| Product/Trade Name: | ARTIS icono biplane, ARTIS icono floor, ARTIS pheno | EU-SRN | DE-MF-000006122 |
| | | Corrective Action ID | AX003/22/S, AX004/22/S |

Customer Safety Information (CSI) for Field Safety Corrective Action

Subject: Software update of ARTIS systems with software version VE20 to VE21

Figure 1: C-Arm position in singularity

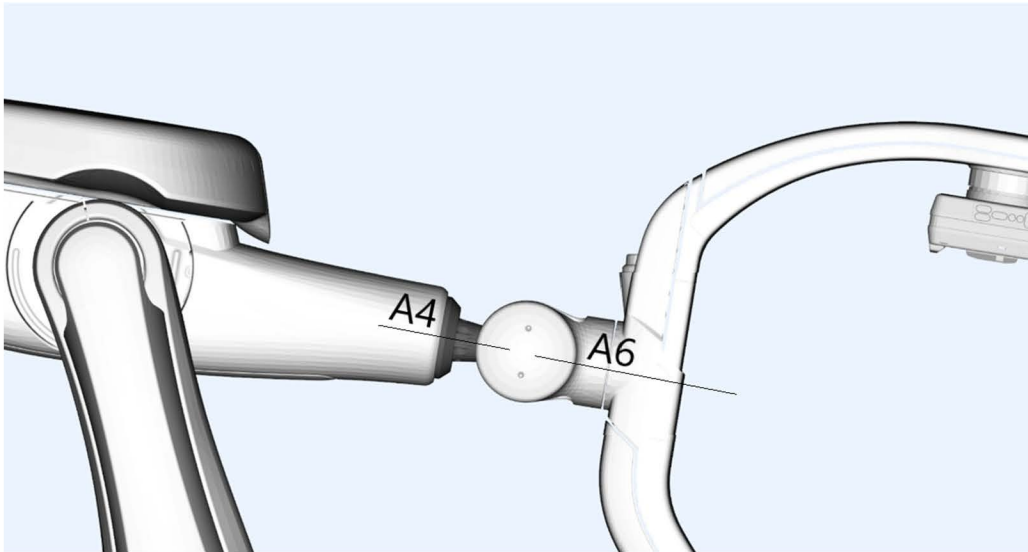
In special, clinically untypical positions of the ARTIS pheno stand (see figure 1) the robot may move into a so called singularity position, where the movement may get stopped and blocked.

If this issue occurs, all stand movements are blocked and can only be reactivated by a field service engineer. Depending on the status of the intervention, the limited functionality may not be sufficient to continue with treatment as planned. This may result in a situation where it is necessary to cancel clinical treatment or to continue treatment on an alternative system.

The issue has been identified in the field in combination with a suboptimal system adjustment only. The root cause for the blocked stand movement is a software issue.

Please consider the need to establish emergency procedures to manage situations related with the failure of your ARTIS system according to the User Manual.

The software will be updated.
